STAFF RECOMMENDATION 2216 Belmont Boulevard June 15, 2016

Application: New construction- addition and outbuilding; Partial demolition
District: Belmont-Hillsboro Neighborhood Conservation Zoning Overlay
Council District: 18
Map and Parcel Number: 10416035800
Applicant: Manuel Zeitlin
Project Lead: Melissa Sajid, Melissa.sajid@nashville.gov

Description of Project: Application is to demolish a non-contributing rear addition, to construct a rear addition, and to construct a new structure in the rear yard.

Figure 2 (left) is the 1951 Sanborn Map. Figure 3 (right) shows the rear addition.

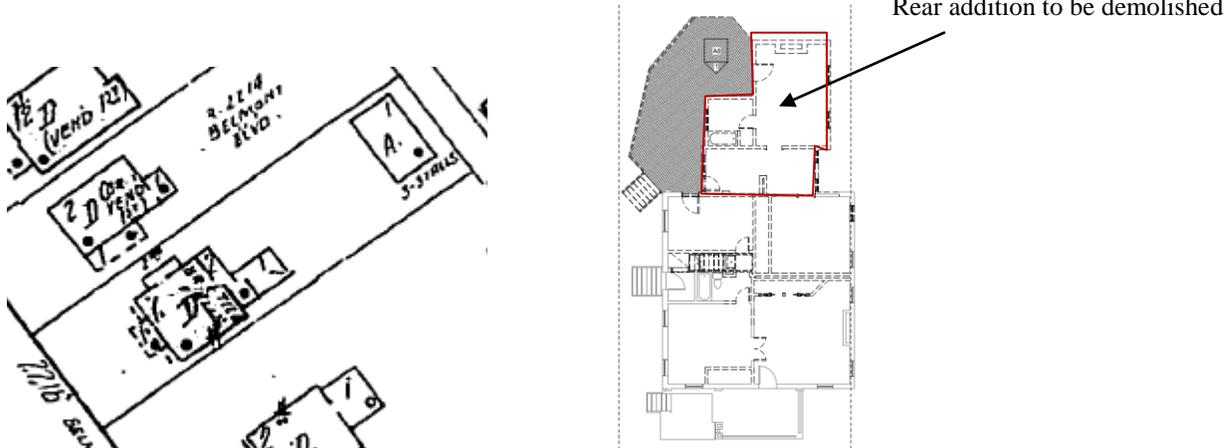
Partial Demolition: The applicant proposes to demolish a four hundred and seventy-one square feet (471 sq. ft.) non-contributing addition and deck to the historic house. The date of construction of the addition is unknown, but it was built prior to the creation of the neighborhood conservation zoning overlay in 2005. A version of a rear addition appears on the 1951 Sanborn map (Figure 2); however, the footprint is different from the existing footprint (Figure 3). The portion to be removed is inset differently on the right side and does not at any point extend the full width of the house.

Staff finds that the existing rear addition does not contribute to the historic character of the house. The location and inset indicate that it is an addition, and comparison of the existing footprint to the 1951 Sanborn map footprint shows that the addition is not original to the historic house. Staff therefore finds that the partial demolition meets Section III.B.2 for appropriate demolition and does not meet Section III.B.1 for inappropriate demolition.

Figure 4: This image shows the scale of the outbuilding compared to the addition of the home to its right.

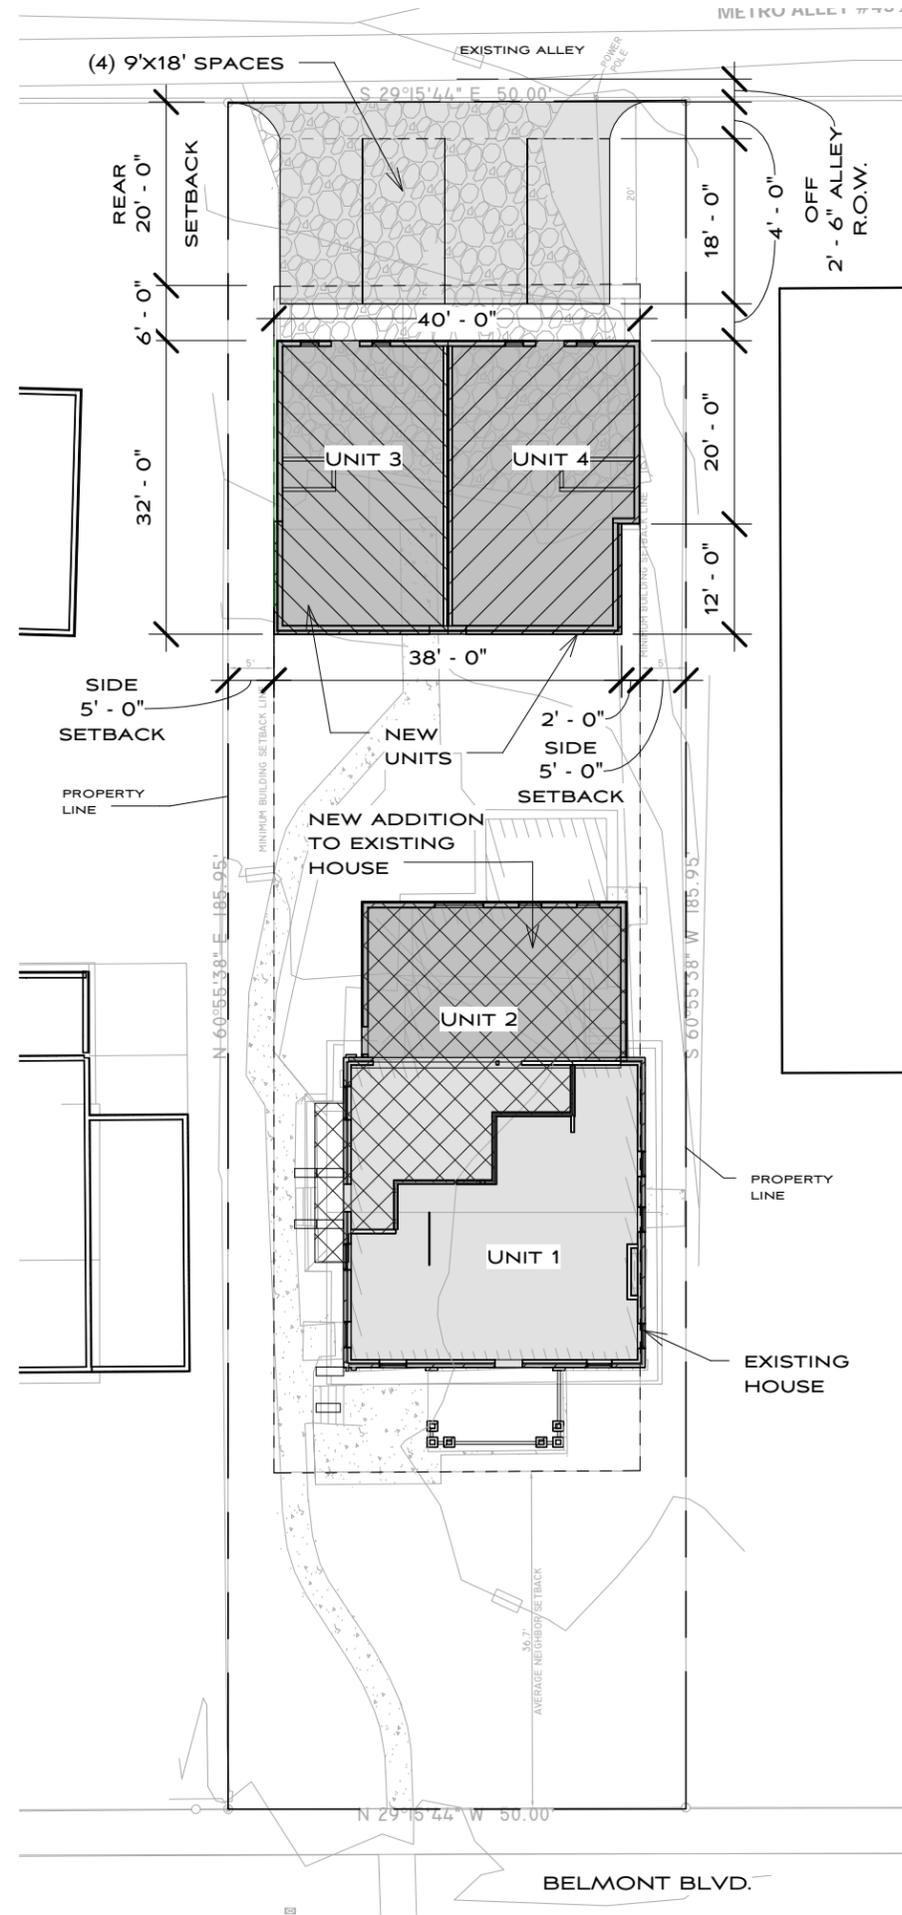
While the proposed additional height could be appropriate in this specific location because of the zoning of the property and the context, staff finds that the additional width is not appropriate, especially when combined with additional height. Historically, outbuildings were subordinate to principle dwellings and had massings which are significantly smaller in terms of width, height and square footage. In most cases, the guidance for outbuildings has specific size requirements; however, those are not relevant here because of the multi-family zoning of the property, which permits up to four (4) units. Allowing more than one (1) unit in the outbuilding is more appropriate to the context than requiring three (3) units in the addition as it will allow the rear yard open space to correspond with the rear yard of the home to the left and push more massing to the rear, to be in line with the large addition to the right.

Even with the realities of the zoning and non-historic context, staff finds the massing to be too large. Since this building is both taller and wider than the principle building, it is not compatible with surrounding historic outbuildings in terms of height and scale. Staff recommends reducing the width of the outbuilding to match the existing width of the historic building. With this condition, the project would meet section II.B.i.1.

1. The detached building shall not be wider than the historic house;
2. Staff approve the final foundation, roof , windows, doors, and railing selections as well as the color and texture of the masonry prior to purchase and installation;
3. The HVAC be located behind the house or on either side, beyond the mid-point of the house; and
4. Staff approve the roof color, dimensions and texture.

SITE PLAN
PROPOSED PLAN

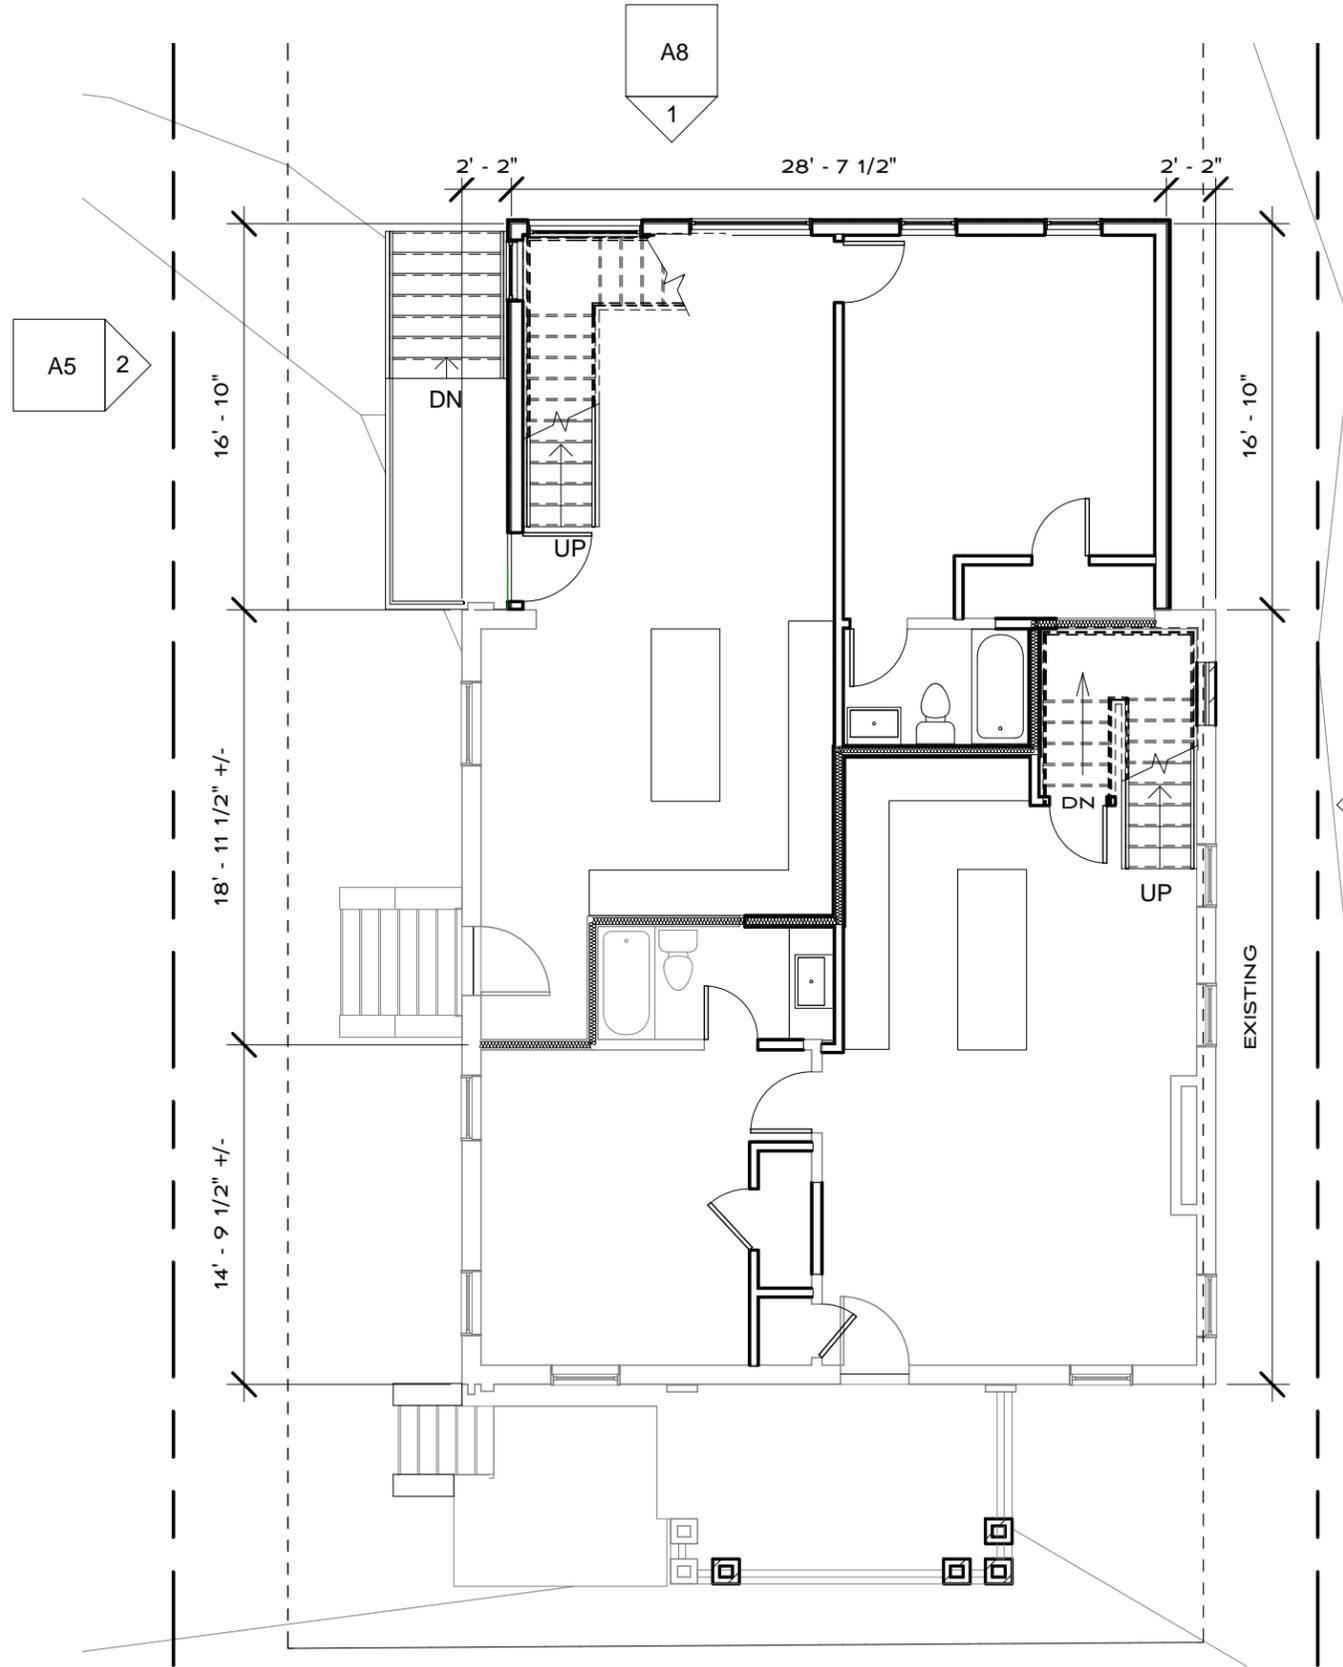
Setback: The setbacks will be approximately fourteen feet (14') on the left side, and six feet (6') on the right side. The rear wall of the addition will be approximately eighty-five feet (85') from the rear property line. The setbacks meet the bulk regulations of the Zoning Code and are consistent with the surrounding historic context. Therefore, staff finds that the project meets Section II.B.2.c for setbacks.

Location, Setback: The detached building will be located at the rear of the lot with vehicular access and parking from the alley. The structure is located twenty-six feet (26') from the rear property line, and five feet (5') from both side property lines; the building meets all setbacks per the Zoning Code. The detached building is located approximately twenty-eight feet (28') from the principle structure, which is more than the twenty feet (20') typically required for detached structures that include a dwelling unit. Staff therefore finds that the proposed structure meets Section II.B.i.2. of the design guidelines.
